Contract #: 04-0120F4Cty: SF/ALA Rte: 80 PM: 13.2/13.9File #: 69.25B**QUALITY ASSURANCE -- NON-CONFORMANCE REPORT****Location:** Shanghai, China**Report No:** NCR-000012**Prime Contractor:** American Bridge/Fluor Enterprises, a JV**Date:** 30-Sep-2007**Submitting Contractor:** Zhenhua Port Machinery Company, Ltd (ZPMC), Changxing Island**NCR #:** ZPMC-0008**Type of problem:**

**Subject:** NCR No. ZPMC-0008

**Reference Description:** Repairs to skin plate welds greater than 10% in length on the 114m Mock-up

**PROJECT: San Francisco Oakland Bay SAS Bridge Superstructure**  
**Caltrans Contract No. 04-0120F4**  
**ABF Job No. 660110**

DRAWN	14-shanghua	SHEET NO.	DRIVER NO.
CHECKED	2007-10-20	RP-01

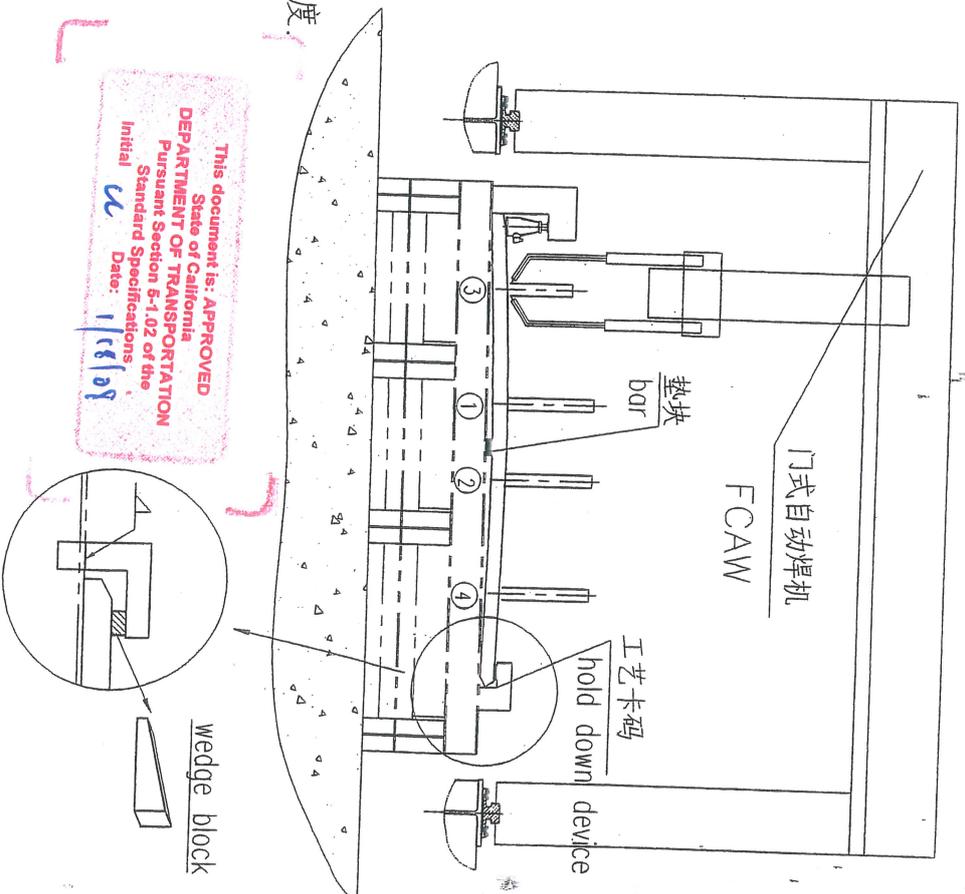
**Description of Nonconformance:**  
**不符合项状态描述:**  
 A number of welds for Skin Plates A MA106 and B MA-101 have defects as defined by AWS D1.5, that were found by Ultrasonic Testing with cumulative lengths in excess 10% of the weld lengths. Cumulative length of indication for the welds in question were found to range of 11% to 45.4% on welds 5&7 of A MA-106 and welds 5, 5R1, and 8 on b MA-101. American Bridge/Flour allowed repairs to be carried out without notifying Caltrans Quality Assurance.  
 A 面板 MA106 和 B 面板 MA101 的很多焊缝具有 AWS D1.5 定义的缺陷, 他们被 UT 发现累计长度超过 10%。A 面板上焊缝 5&7 及 B 面板上焊缝 5, 5R1 和 8 的缺陷范围为 11%到 45.4%。承包商允许在不通知加州 QA 的情况下进行返修。

Step 1. Fit up of Longitudinal Stiffener to Skin Plate.

- 1.1. 在装配纵向筋之前,按照已批准的图纸要求将纵向筋加工到位,
- 1.1. Machine approved weld detail bevels onto longitudinal stiffeners.
- 1.2. 在面板上划好纵向筋的装配线.
- 1.2. Lay out Skin plate and mark longitudinal stiffener positions.
- 1.3. 在两端增加好可调卡码(如右图),安装并根据已批准的WPS的要求把纵向筋点焊固定在面板,检测其垂直度.
- 1.3 Install adjustable holding down device, assemble and tack weld the longitudinal stiffeners to Skin plate inline with the parameters of the approved WPS and check the verticality to the Skin plate.
- 1.4. 对所有尺寸进行检查.
- 1.4. Check all the dimensions.
